Contract #: 04-0120F4Cty: SF/ALA Rte: 80 PM: 13.2/13.9File #: 69.25B**QUALITY ASSURANCE -- NON-CONFORMANCE REPORT****Location:** Changxing Island, Shanghai, PRC**Report No:** NCR-000336**Prime Contractor:** American Bridge/Fluor Enterprises, a JV**Date:** 29-Jun-2009**Submitting Contractor:** Zhenhua Port Machinery Company, Ltd (ZPMC), Changxing Island**NCR #:** ZPMC-0310**Type of problem:**

**Reference Description:** Base metal gouges in East Tower, Lift 4, Skin Plate E to aid longitudinal stiffener fit-up**Description of Non-Conformance:**

**Subject:** NCR No. ZPMC-0310

**Job Name:** SAS Superstructure

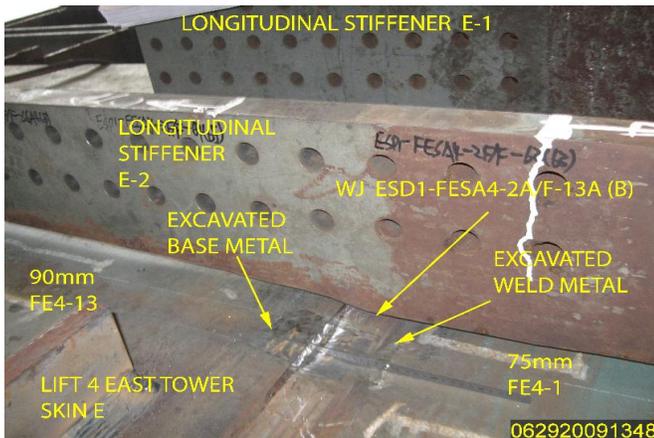
During in-process inspection of Lift 4, East Tower, Skin E, QA randomly observed two excavations at weld joint ESD1-FESA4-2A/F-13A(B) between 90mm plate FE4-13 and 75mm plate FE4-1. The excavations were made in the base and weld metals to allow for fit up of Longitudinal Stiffeners E1 and E2 to Skin Plate E. The repair procedure was not submitted nor approved by the Engineer at the time of repair.

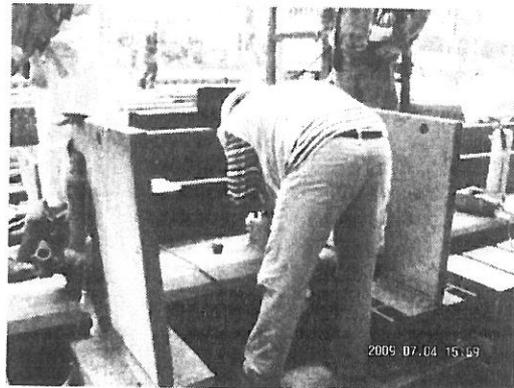
About this situation Charles Franco found this problem, and then we issued the T-CWI171 approved by the CT engineer, and we did the MT and UT work about the repair work. And the CT inspector Baskar did the inspection about the MT and the UT work (see attachment photos) to make sure no problem.

Draft of Welding Discontinuity:

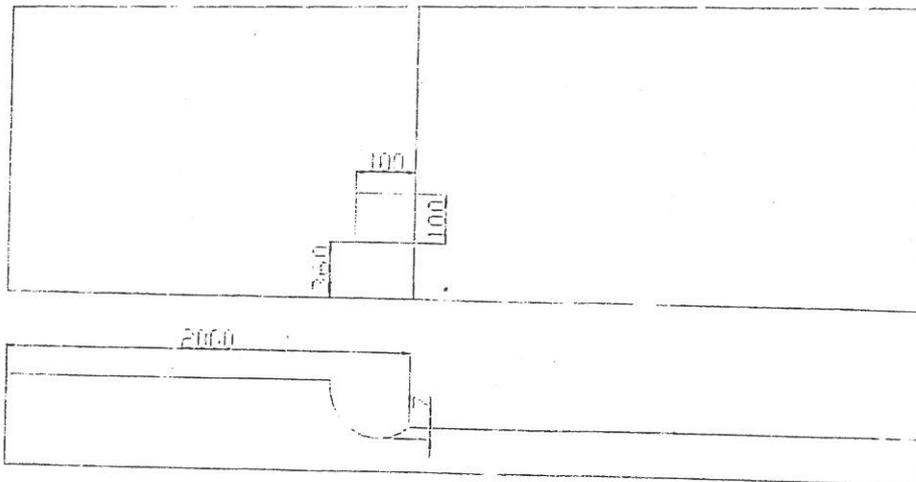
东塔第四吊装段E面板，在装配纵向筋时，焊缝打磨过度造成母材损伤，经测量最大处深度为7MM。见照片示意图。

East tower fourth lifting Skin E, the base metal was 7mm gouged during grinding and assembly stiffener, see the following draft.

阴影部分为割伤区域。Gouged area in shadow.

1. A leader CWI shall be present during CWI.
2. Grind the build-up area to a smooth and shiny surface finish in preparation for welding.
3. Preheat and weld passes according to the approved WPS.
4. Build-up should be 2-3 mm greater than the final dimension.
5. Grind, to final dimension, the weld built-up area to a smooth and shiny finish.
6. Perform VT, MT and UT over 100% of the built-up area.

#### Draft of Welding Discontinuity:

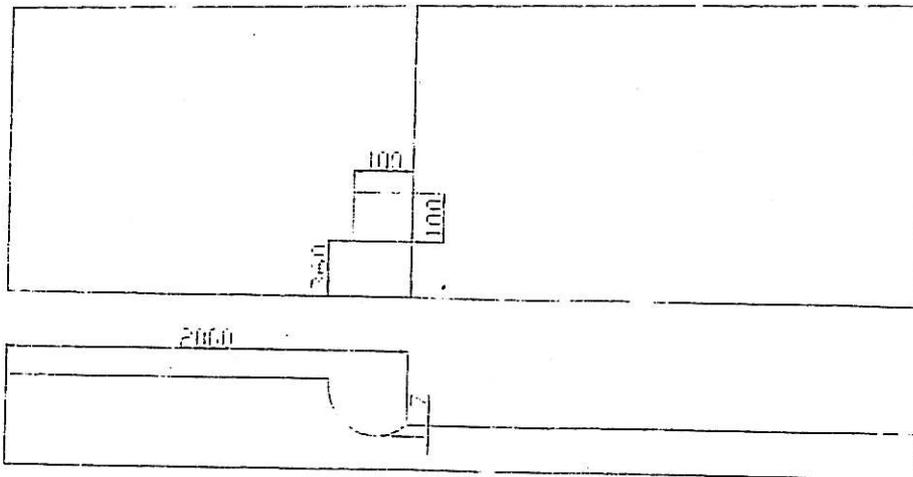
东塔第四吊装段E面板，在装配纵向筋时，焊缝打磨过度造成母材损伤，经测量最大处深度为7MM。见照片示意图。

East tower fourth lifting Skin E, the base metal was 7mm gouged during grinding and assembly stiffener, see the following draft.

阴影部分为割伤区域。Gouged area in shadow.

1. A leader CWI shall be present during CWI.
2. Grind the build-up area to a smooth and shiny surface finish in preparation for welding.
3. Preheat and weld passes according to the approved WPS.
4. Build-up should be 2-3 mm greater than the final dimension.
5. Grind, to final dimension, the weld built-up area to a smooth and shiny finish.
6. Perform VT, MT and UT over 100% of the built-up area.

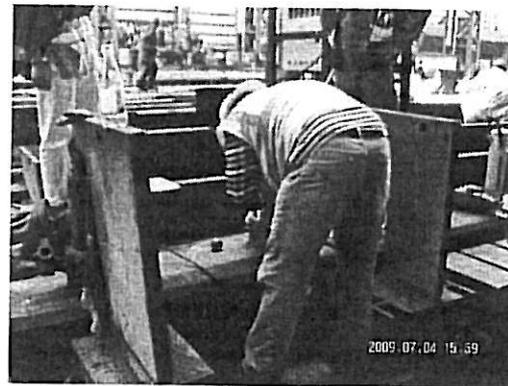
1、 About this situation Charles Franco found this problem, but he mentioned 90mm plate FE4-13, the real of this plate thickness is 100mm

2、 We issued the T-CWI171 approved by the CT engineer, and we did the MT and UT work about the repair work. And the CT inspector Baskar did the inspection about the MT and the UT work (see attachment photos) to make sure no problem.

焊缝返修位置示意图:

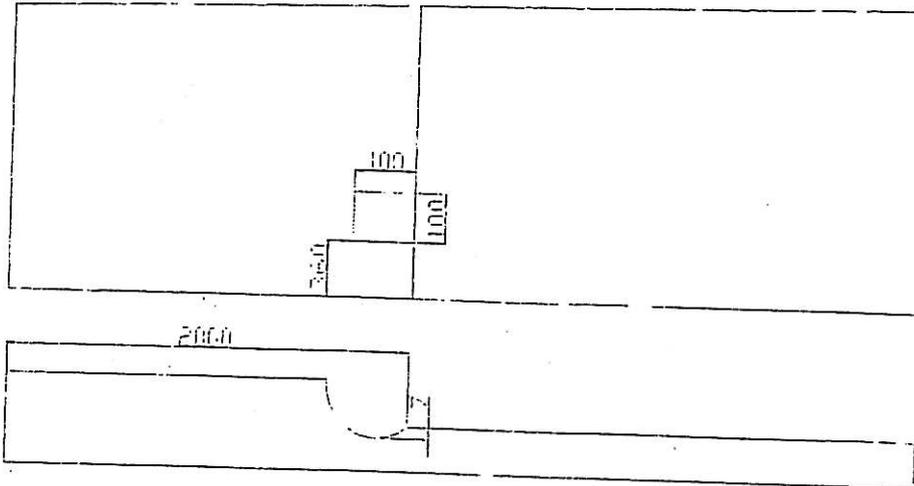
东塔第四吊装段E面板，在装配纵向筋时，焊缝打磨过度造成母材损伤，经测量最大处深度为7MM。见照片示意图。

East tower fourth lifting Skin E, the base metal was 7mm gouged during grinding and assembly stiffener, see the following draft.
